Access Compliance Report

Public Rights-of-Way

(Curb Ramps)

Intersection ID: 11051	Main Street: E_21ST_ST	Cross Street: N_BREVARD_ST	Location: S
ADA ID: D62DB90C1FD3	Ramp Type: PerpDiag	Initial Pass/Fail: Fail	Overall Compliance: No
Severity Score: 22.5			
Codes/Mitigation Info/Possible Solution		Field Measurements/Component Compliance

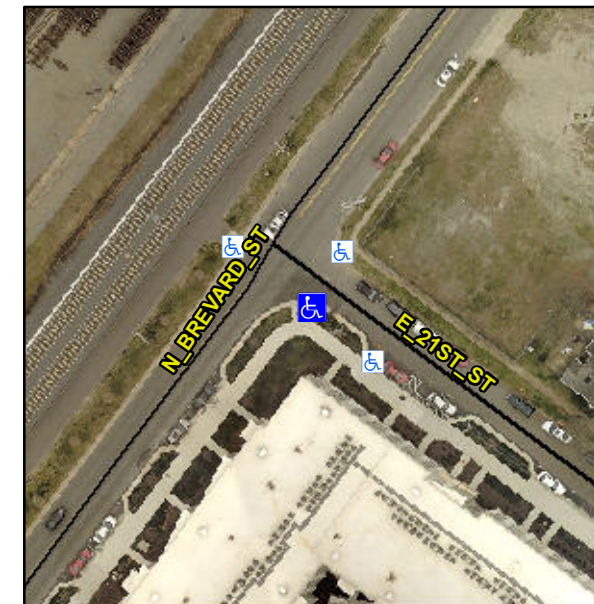
R304.5.1, R304.2.2, R304.5.3

Compliance	Description	Data	Compliance	Description	Data
N/A	Ramp Length (in)	92.0	No	Ramp Slope (%)	8.5
No	Ramp Width (in)	47.0	No	Ramp XSlope (%)	2.3
N/A	Flare Type LT	N/A	N/A	Flare Type RT	N/A
N/A	Flare Slope LT (%)	N/A	N/A	Flare Slope RT (%)	N/A
N/A	Flare Traversable LT?	N/A	N/A	Flare Traversable RT?	N/A
N/A	Landing Length (in)	N/A	N/A	DWS Provided?	N/A
N/A	Landing Width (in)	N/A	N/A	DWS Contrast?	N/A
N/A	Landing Slope (%)	N/A	N/A	DWS Length (in)	N/A
N/A	Landing X Slope (%)	N/A	N/A	DWS Full Width?	N/A
N/A	Landing Curb? (Y/N)	N/A	N/A	DWS Offset (in)	N/A
N/A	Shared Landing?	N/A			
N/A	Gutter Ponding?	N/A	N/A	Gutter Slope (%)	N/A
N/A	Gutter Lip Ht (in)	N/A	N/A	Gutter X Slope (%)	N/A
N/A	Painted X Walk1?	No	N/A	Painted X Walk2?	No
	X Walk 1 Direction	To NE		X Walk 2 Direction	To NW
N/A	X Walk 1 Width (in)	N/A	N/A	X Walk 2 Width (in)	N/A
	X Walk 1 Slope (%)	0.4		X Walk 2 Slope (%)	2.8
	X Walk 1 X Slope (%)	1.9		X Walk 2 X Slope (%)	0.3

Remove & Replace Curb Ramp With Two New Directional Ramps or Equivalent.
